METROPOLITAN GOVERNMENT OF NASHVILLE AND DAVIDSON COUNTY

STAFF RECOMMENDATION 1518 Sixteenth Avenue South March 18, 2015

Application: New construction-infill
District: South Music Row Neighborhood Conservation Zoning Overlay
Council District: 19
Map and Parcel Number: 10408041200
Applicant: Jamie Pfeffer, Pfeffer Torode Architecture
Project Lead: Robin Zeigler, robin.zeigler@nashville.gov

Figure 2. Side view of proposed entrance.

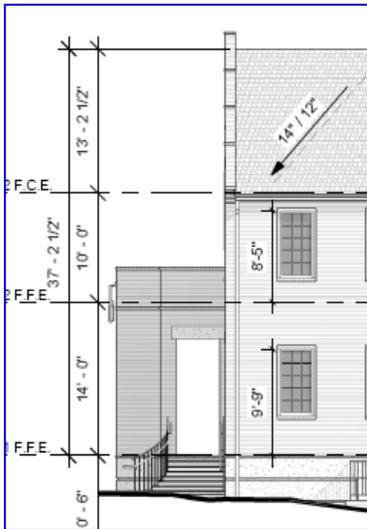
The building shape includes a recessed entrance. There are examples within the district of similar configurations.

Staff finds the height, scale and building shape compatible with surrounding historic buildings, and the project meets section II.B.1. b and c.

Figure 3. Example of a parapet roof in the neighborhood.

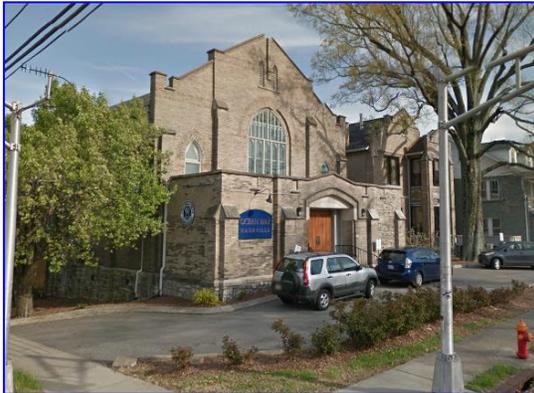
Roof form: The roof form appears as a hipped roof behind a stepped parapet. Although parapet roofs are not found on residential buildings, they are found on non-residential historic buildings in the overlay and in the neighborhood beyond the overlay boundaries. The project meets section II.B.1.d.
